Thank you for your letter dated 7th September to the Land Use Planning advice team of the Health and Safety Executive (HSE) requesting comments on the planning application for a temporary change of use of the MOD Bicester A site for the phased provision of non-detained asylum accommodation (application no: PCU/RARE/C3105/3378843).

Re: PCU/RARE/C3105/3378843 - Application by the Home Office for the temporary change of use of the defence storage & distribution centre site (MOD Bicester A - site) in connection with the phased provision of non-detained asylum accommodation at MoD Bicester (A-Site), Bicester Garrison, Launton Road, Piddington, OX25 1AE

COUNTY COUNCIL'S RESPONSE TO CONSULTATION ON THE FOLLOWING DEVELOPMENT PROPOSAL

District: Cherwell
Application no: PCU/RARE/C3105/3378843 (26/01833/CROWN)
Proposal: Full planning permission for the temporary change of use of the former defence storage & distribution centre site (MOD Bicester A - site) in connection with the phased provision of non-detained asylum accommodation. The Proposed Development comprises the retention and change of use of Building A6, the demolition of existing buildings and structures, the erection of new modu

Figure 3.10 Additional area of visibility on the inside of a curved major road

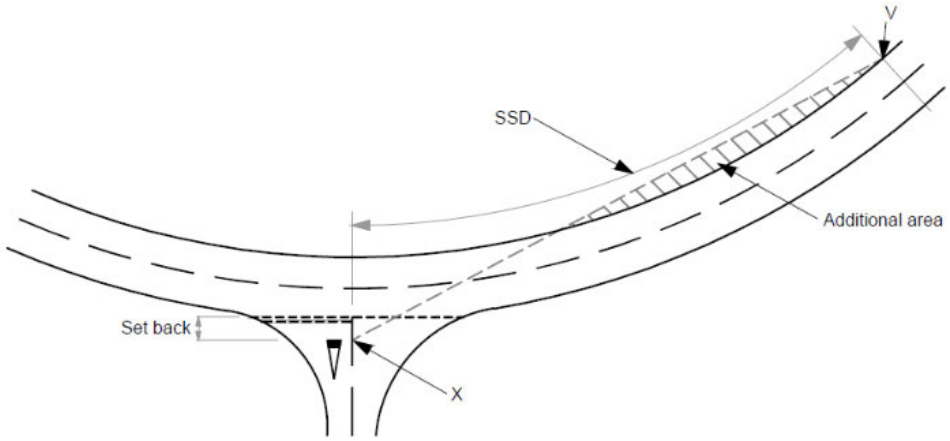
3.7. While I am satisfied that visibility to the left is likely to be achievable, as shown in Image 4-1 of the TA, I have concerns regarding visibility to the right. The drawing shows that the right-hand visibility is significantly offset, requiring an additional area of visibility on the highway verge. The stopping sight distance in this case should have been taken as illustrated in the snippet below.

TE 1 The additional area of visibility on the inside of the curve (as illustrated in Figure 3.10) applies to both the left and right of a priority junction/direct access.

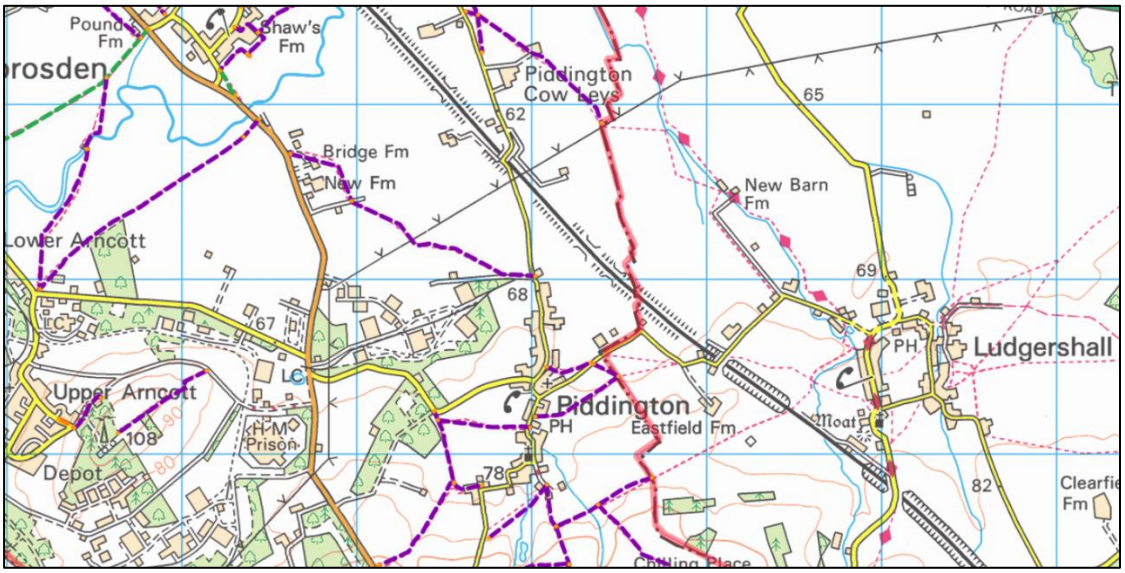
4.4. The TA suggests that a number of amenities shall be provided on site including health services in an attempt to contain external related trips by residents. Shuttle buses/ mini-bus services will be availed for occasions where residents are required to travel to key external amenities or necessary trips. The application however has not identified these key amenities or trips. It is my assumption that Bicester shall serve as the key destination where on-ward travel by other modes to the rest of UK can be accessed.
